2007 General Plan Policy Consistency Analysis

Draft PEDC Design Committee Minutes, May 26, 2016

1. Review and Approval of the minutes from the April 20, 2016 Meeting. *Approved.*
2. DZA 15-002, TTM 16-001, UPA 16-001, and DR 16-004 – Consideration of the amendment to the Old Mammoth Place project, located at 164, 202, and 248 Old Mammoth Road. Staff contact: Nolan Bobroff, Assistant Planner, ext. 227

Public Comment Letters

Prominent Tree Location and Height Clearwater Site - August 2006

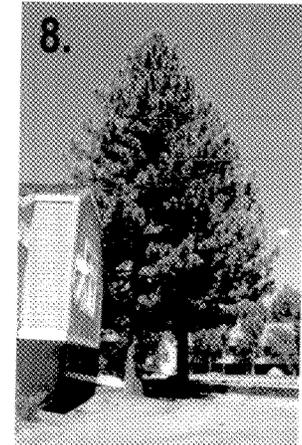
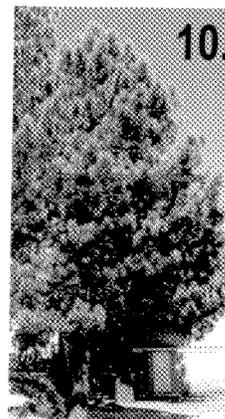
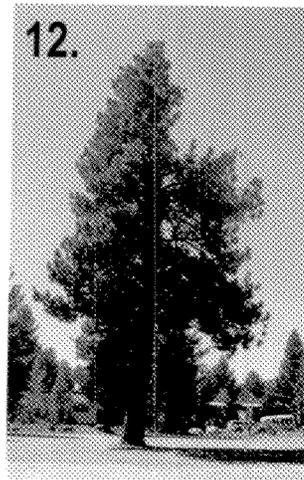
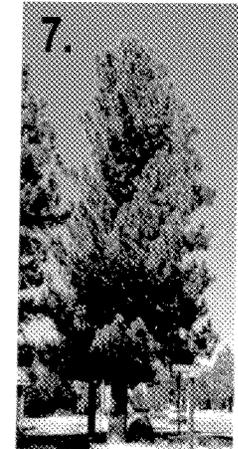
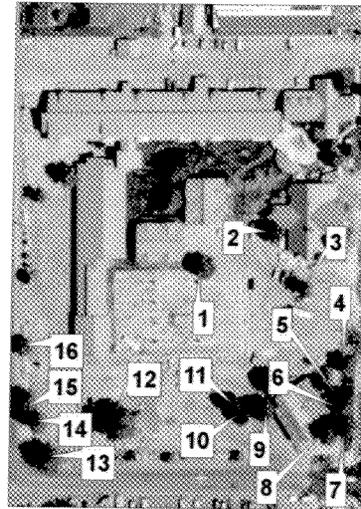
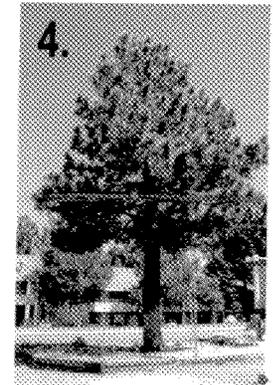
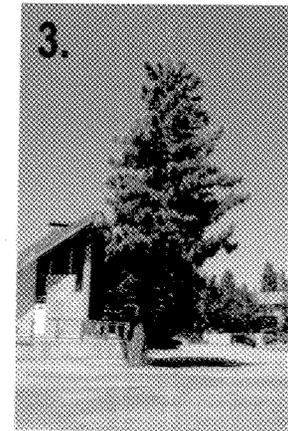
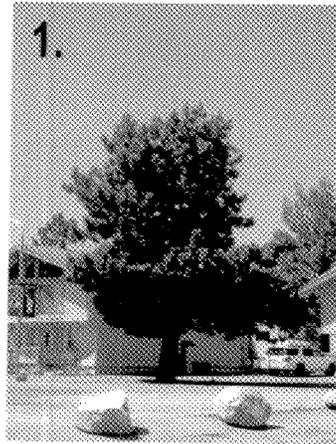
<p>C.2.X. Limit building height to the trees on development sites where material tree coverage exists and use top of forest canopy in general area as height limit if no trees exist on site.</p>	<p>A survey of the existing mature trees on the site completed as part of the original CSP project, revealed the average mature tree height was 63-feet, which is consistent with the maximum proposed height of the project. Additionally, the requested 65-foot height is consistent with the recommendations in the North Old Mammoth Road District Special Study (NOMRDSS) and what was analyzed in the 2008 CSP EIR.</p>
